TOWN OF MILTON
PLANNING AND DEVELOPMENT
BUILDING PERMIT: 17-7100
BUILDING: REVIEWED
SCOTT SHERRIFFS JUN 12, 2017
PLANS EXAMINER DATE
Neither the issuance of a permit nor carrying out of
inspections by the Town of Milton relieves the owner from
full responsibility for compliance with the provisions of
the Ontario Building Code Act and the Ontario Building
Code, both as amended, as well as other applicable
statutes and regulations of the Province of Ontario,
By-laws of the Region of Halton and Town of Milton

JUNIPER 7-119
ENERGY STAR

PROJECT NAME
LECCO RIDGE

SHEET TITLE
**RIGHT SIDE
ELEVATION 2**
SCALE 3/16"=1'-0"
BY V.G.
DATE JUL 2016
TYPE

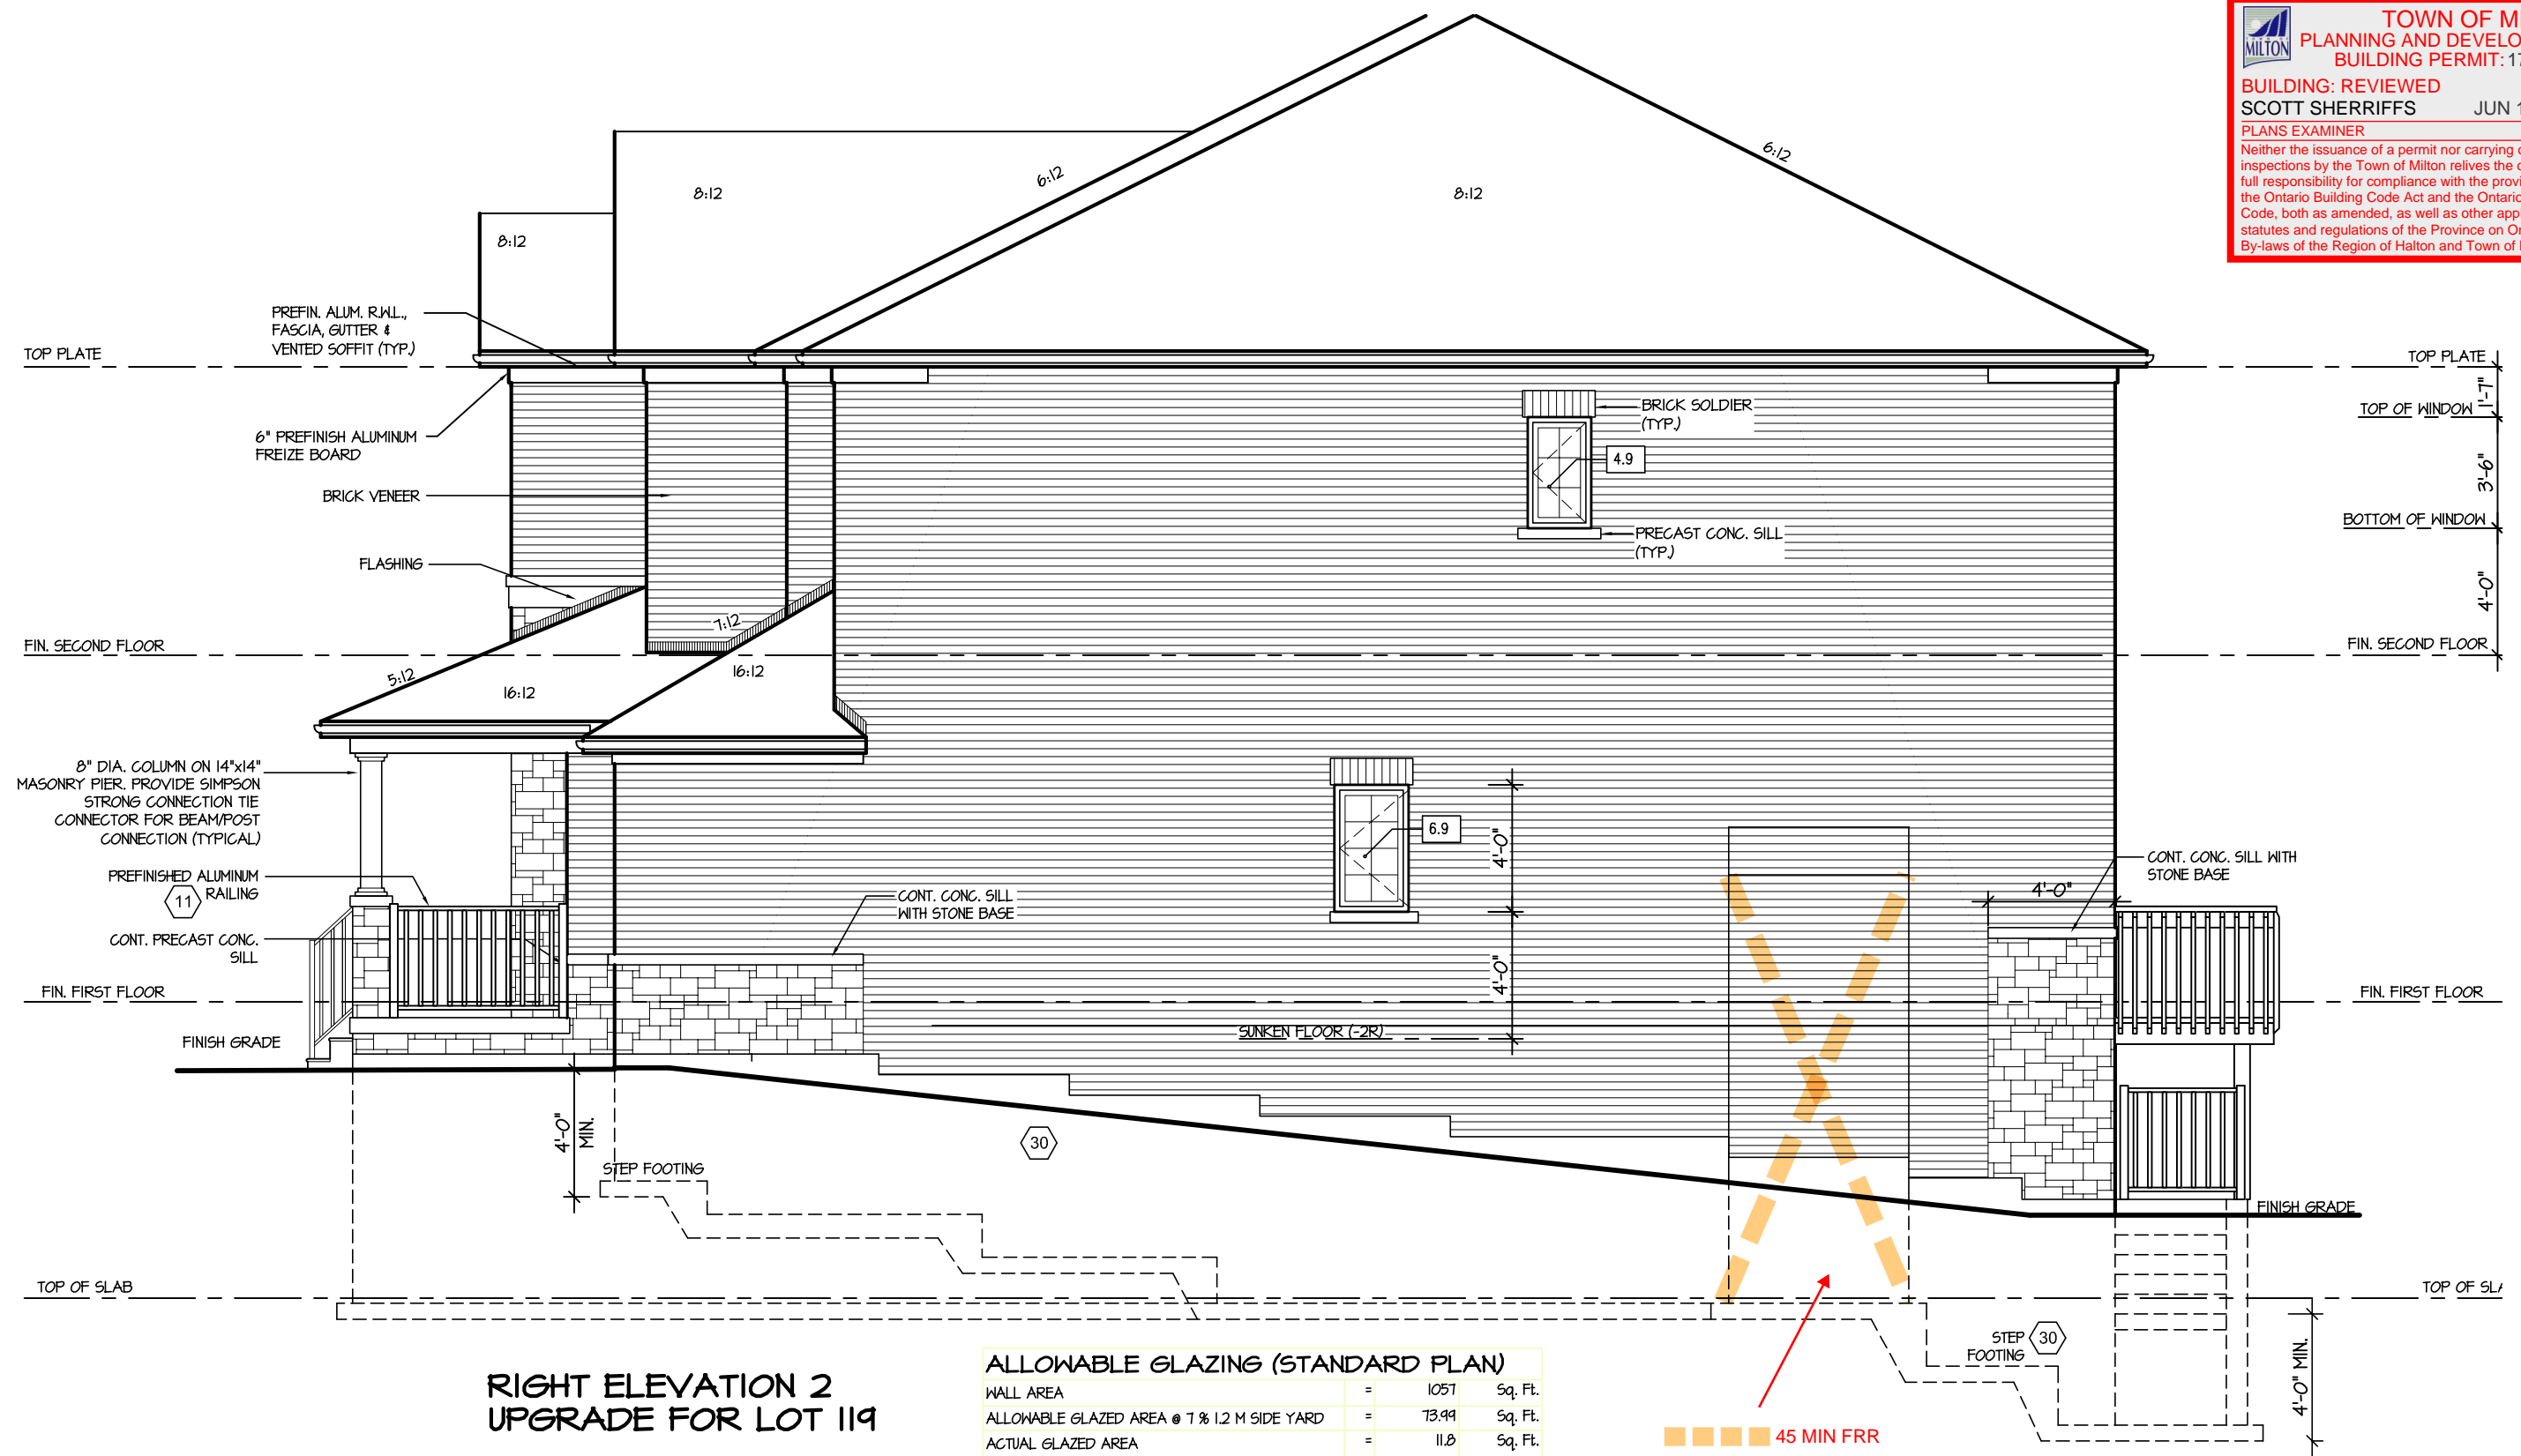
45 MIN FRR
LD <1.2 M FOR BUMPOUT
Fireplace bumpout to be constructed with 45 min FRR as the LD is <1.2 m

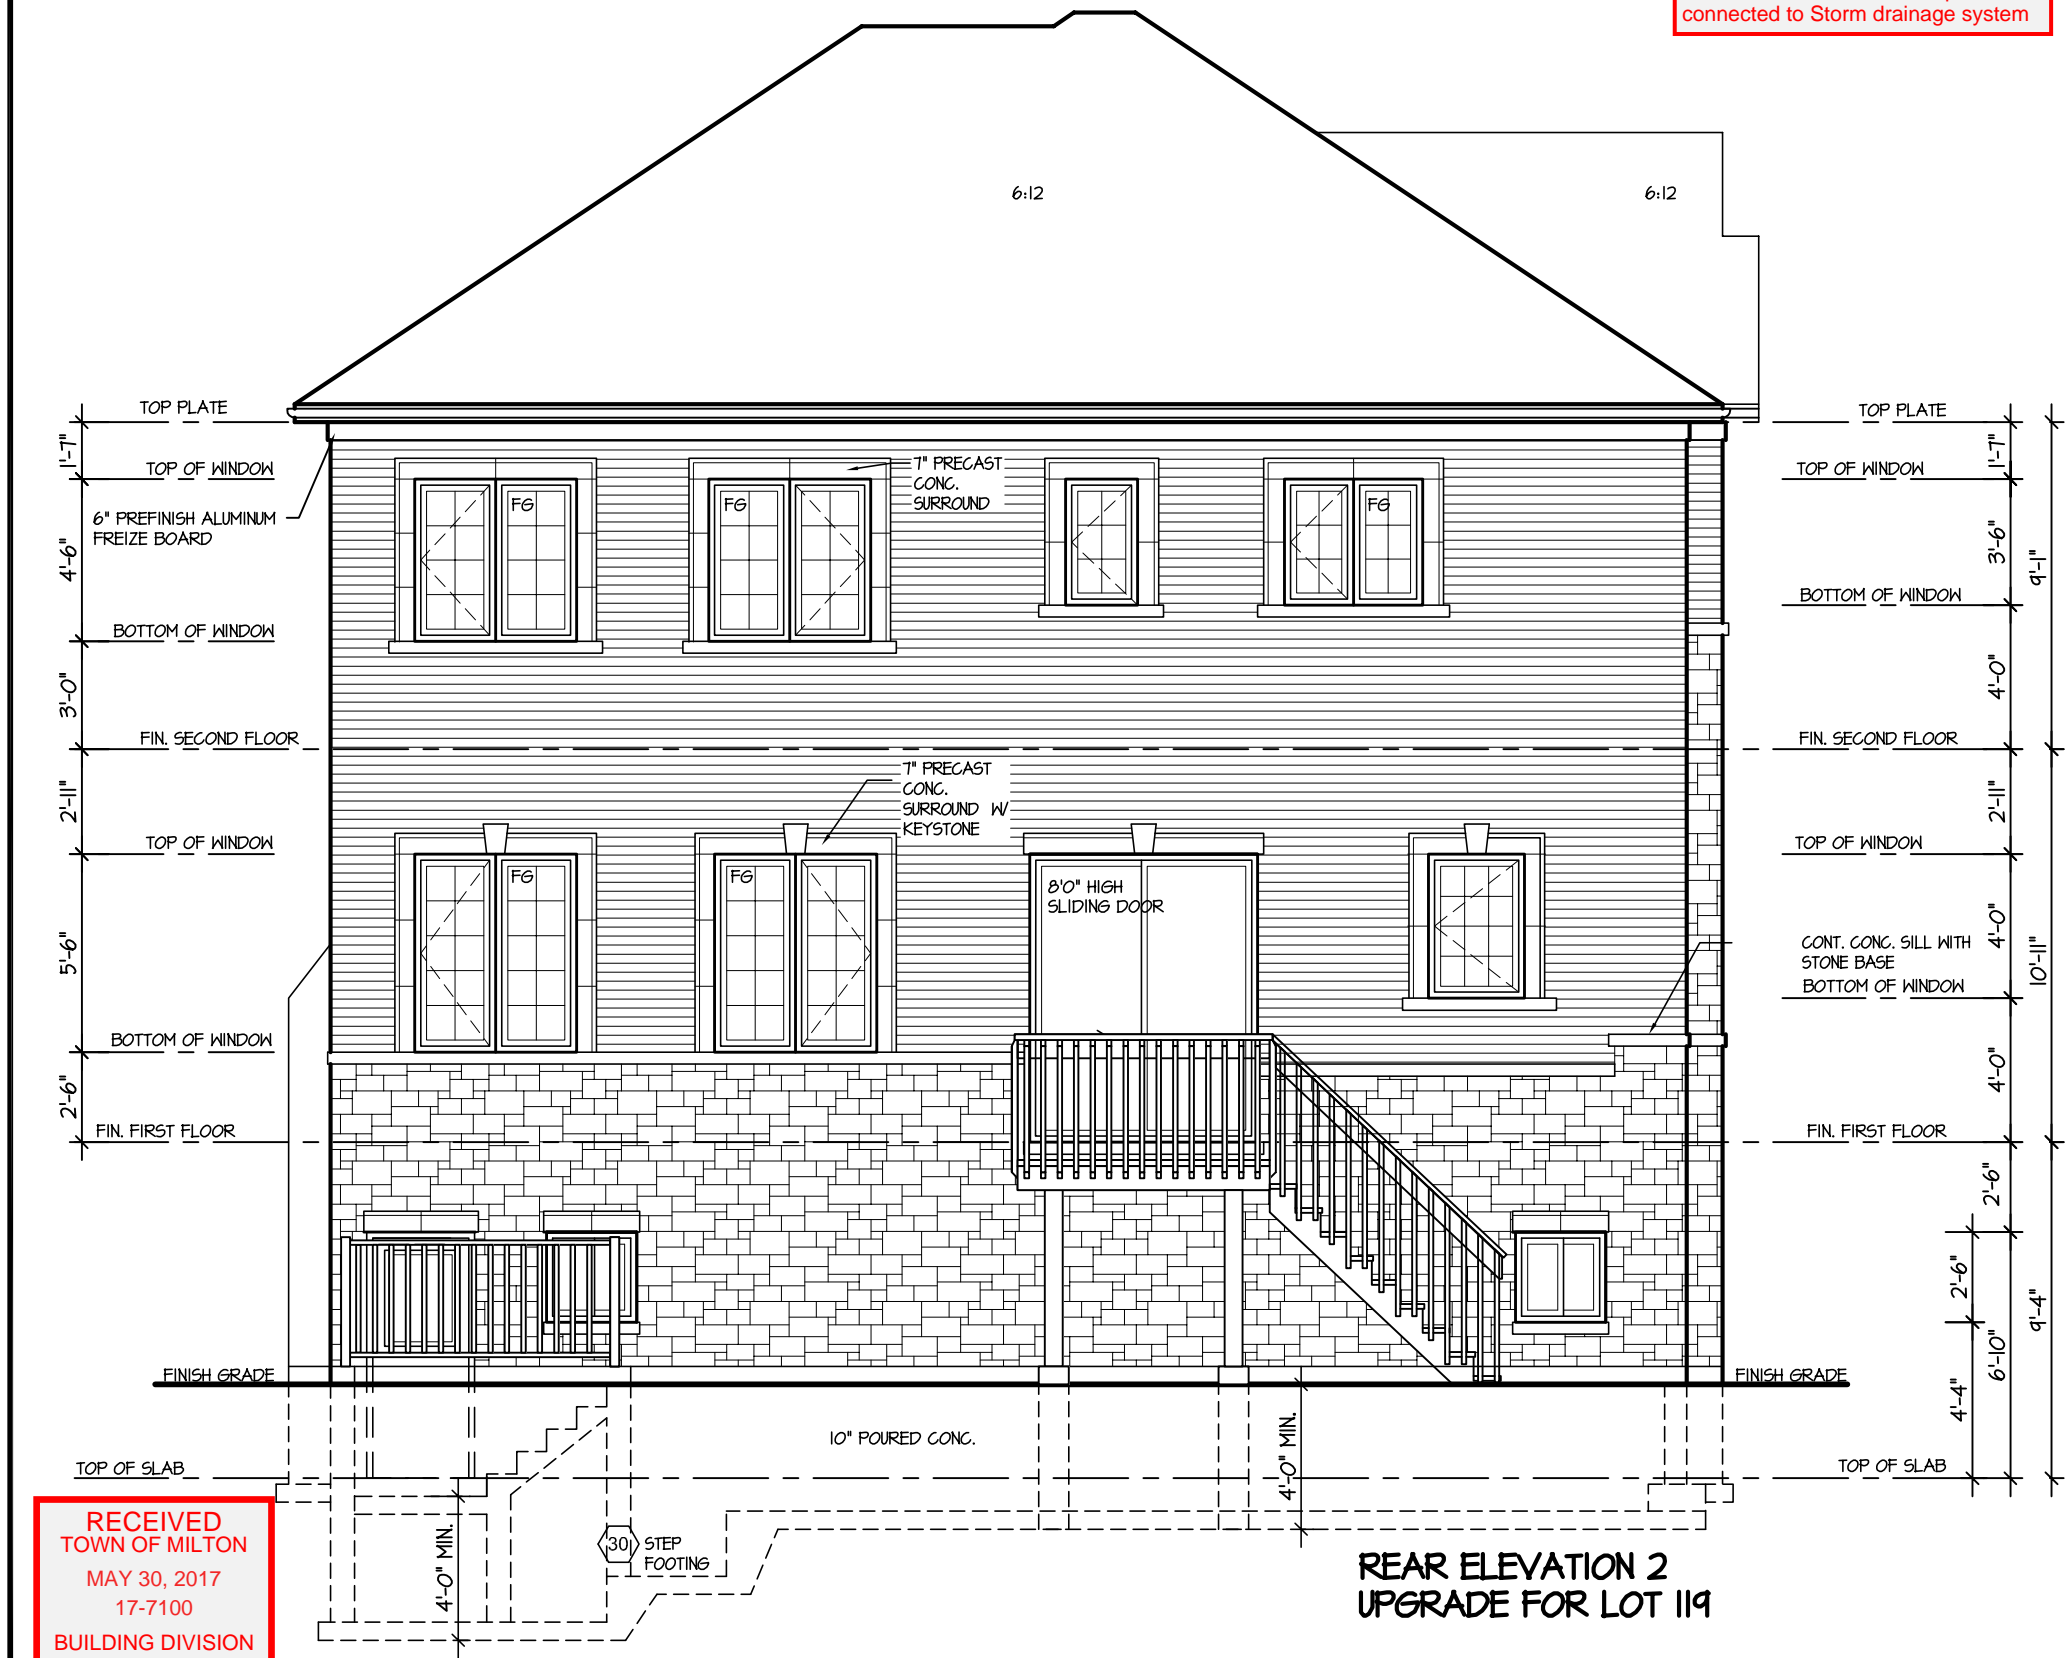
WALKOUT AREA DRAIN
Uncovered walkout landing to have an area drain with sediment trap/bucket connected to Storm drainage system
